I, Scott W. Horsley, depose and state as follows.

7. For purposes of this Affidavit I reviewed engineering plans produced by G.A.F. Engineering Co. (“GAF”) in connection with earth removal operations by AD Makepeace Co. (“ADM”), aerial photographs, and various government databases including Massachusetts Bureau of Geographic Information (MassGIS), United States Geological Survey (USGS), the United States Environmental Protection Agency (USEPA), and Massachusetts Department of Environmental Protection (MassDEP).

11. I have reviewed engineering plans prepared by G.A.F. Engineering showing proposed earth removal by ADM located on and adjacent to three sites on Federal Road in Carver, Massachusetts (Project Sites) and permits including:

Figure 1 - Locus Map

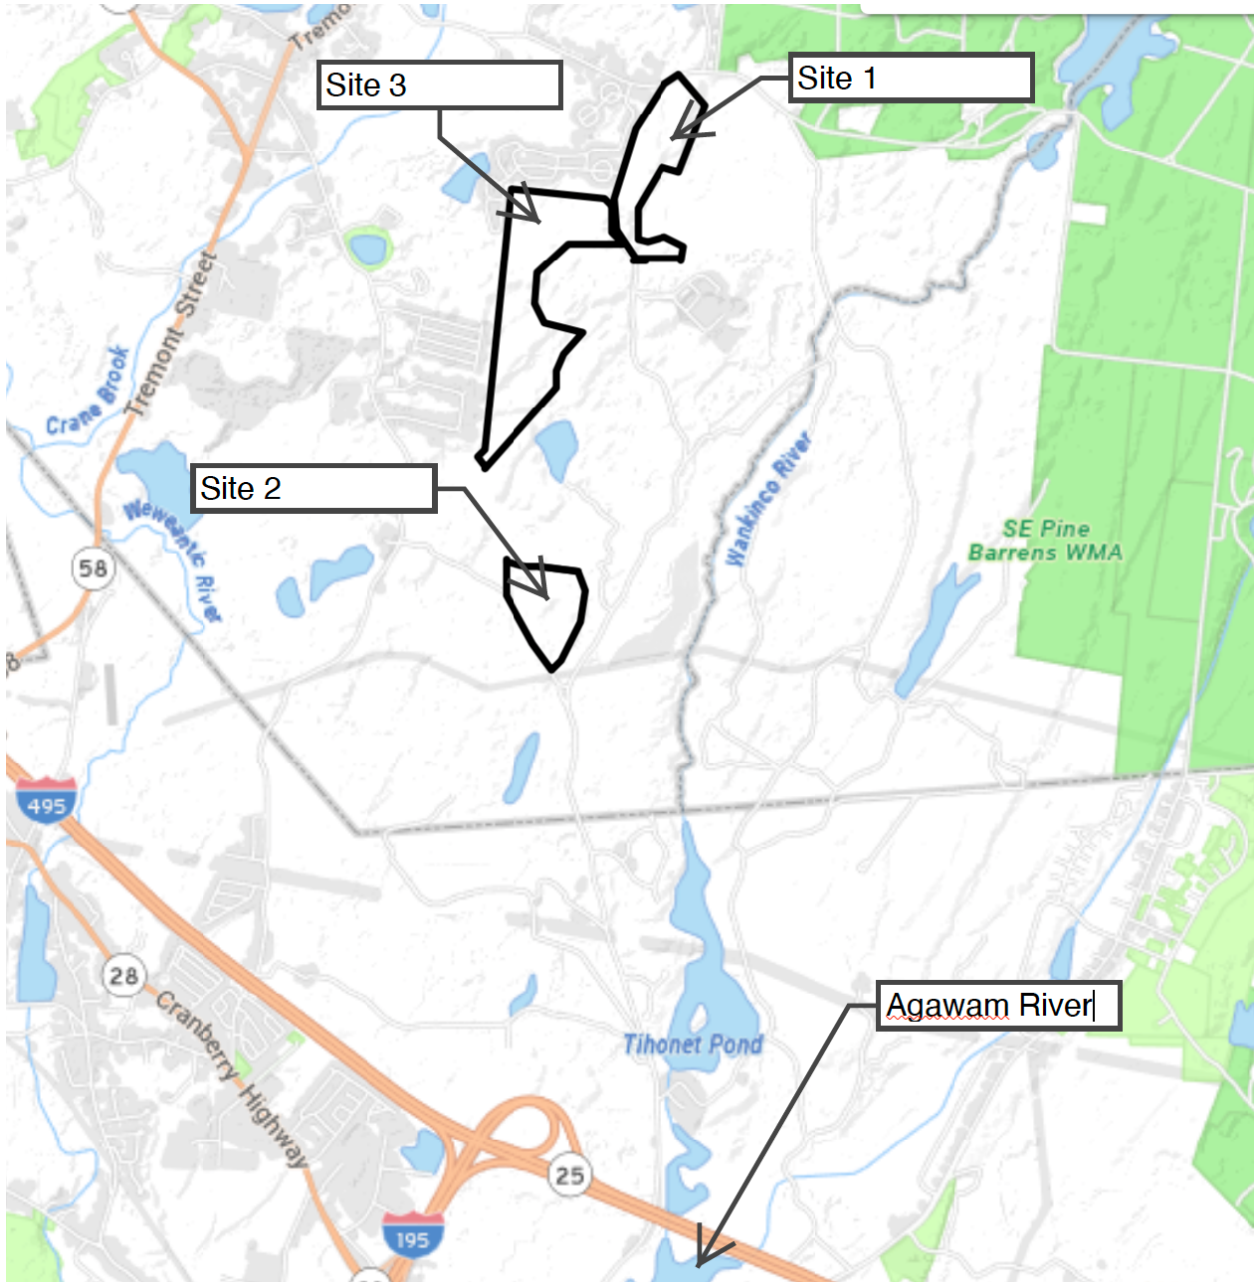
14. The total land area altered on these three Sites between 2020 and 2022 is approximately 153 acres. This has caused significant alterations to the hydrology and water quality in downstream water resources. Additionally, it significantly increases the vulnerability of water resources due to the substantially reduced depth to groundwater.

15. I have prepared hydrologic budget and nitrogen loading analyses to evaluate the impacts of these projects (see Table 1). The hydrologic budget analysis is based upon an existing groundwater recharge rate of 27 inches/year (USGS, 2009) and a post-development recharge rate of 40 inches/year. The increase in recharge rate is a result of the loss of evapotranspiration due to the clear-cutting of trees throughout the project sites. This analysis indicates an increased recharge volume of 54 million gallons/year. The increased recharge will alter wetland levels and baseflow rates in streams.

16. The nitrogen loading analysis utilizes coefficients published by the Massachusetts Estuaries Project (MEP). Average nitrate-nitrogen concentrations in rainfall are estimated at 0.75 mg/liter. In naturally forested areas more than 90% of this nitrogen is assimilated into the forest ecosystem. The clear-cutting of forest on the three project sites has eliminated this assimilation allowing the nitrogen to be exported downstream to the Agawam River that has already been determined to be impaired due to excess nutrients. My nitrogen loading analysis indicates that the three Project Sites have increased the downstream nitrogen loading by 440 kg/year.

Figure 2 - Public and Private Drinking Water Supplies Adjacent to Project Sites

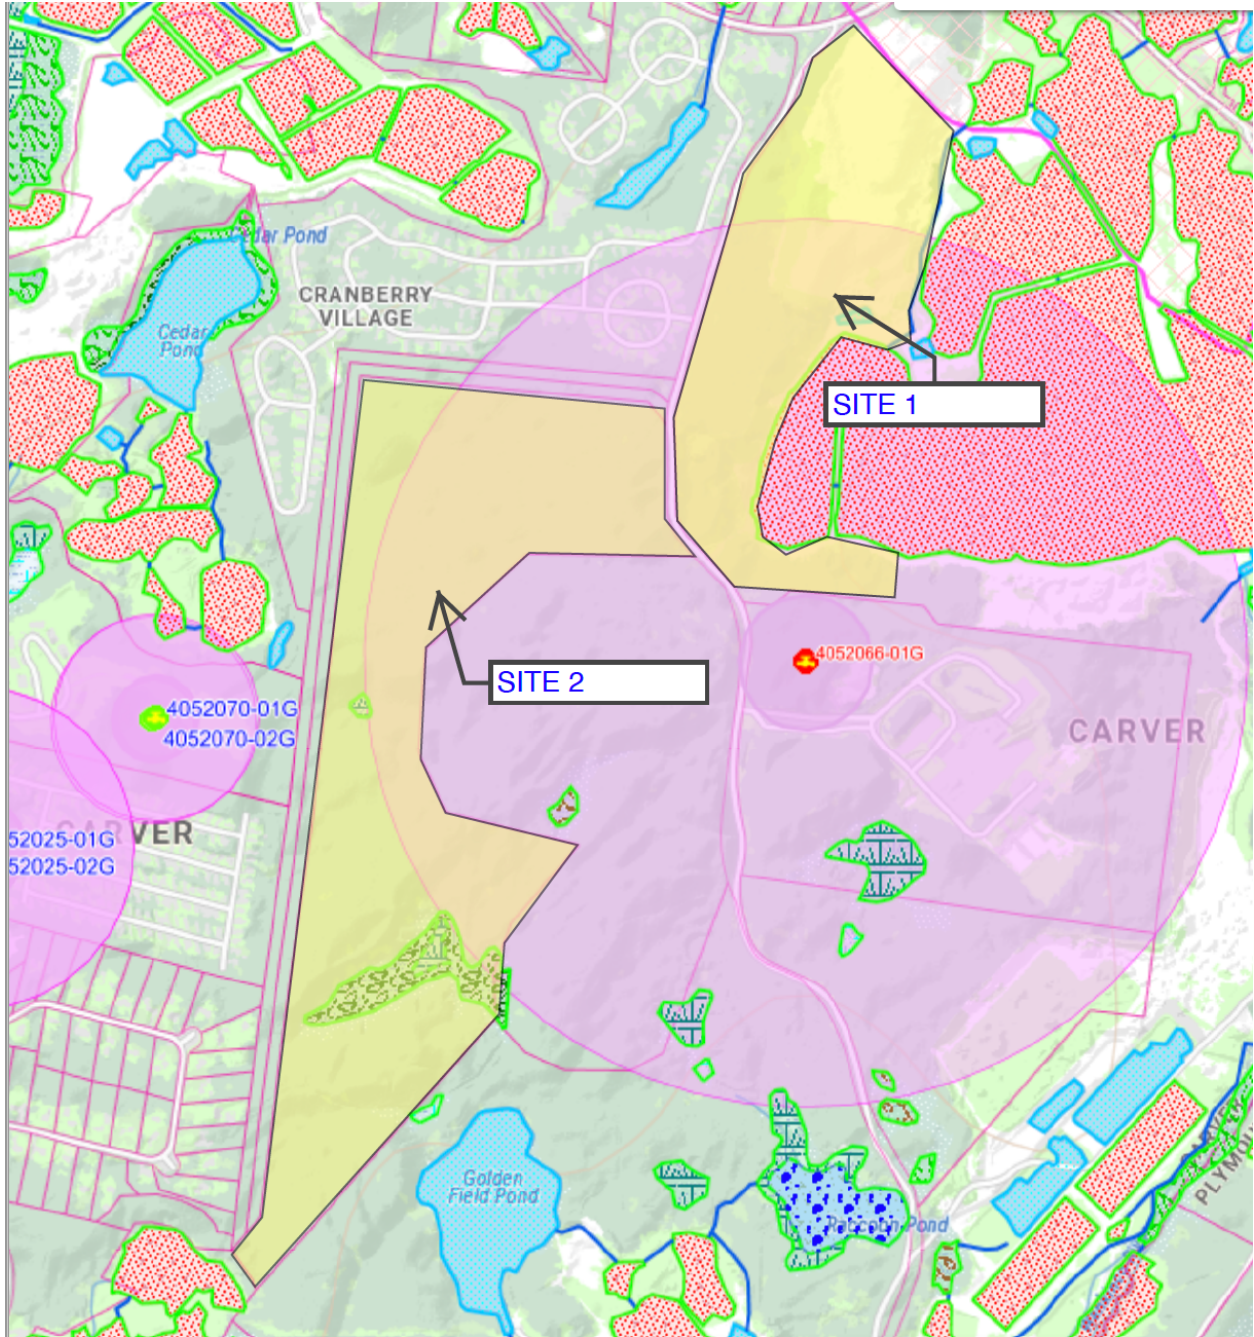
Sites 1 and 3 are within or directly adjacent to multiple public and private drinking water supply sources (see Figure 2). The specific public supply wells are as follows:

Site 1: MassGIS shows that the project site lies within the wellhead protection areas to three public supply wells. The wells include MassDEP numbers 4052067-02G, 4052067-01G, and 4052066-01G. There is also a large jurisdictional wetland immediately adjacent at the east side of the site.

Site 3: MassGIS shows two public water supply wells that are located west of Site 3 and one to the east. These include MassDEP numbers 4052070-01G, 4052070-02G, and 4052055-01G (located at Ocean Spray's cranberry processing facility at 60 Federal Road). The interim Zone 2 areas surround and include the project site. There is also a subdivision immediately to the southwest of the project parcel that is served by private on-lot wells.
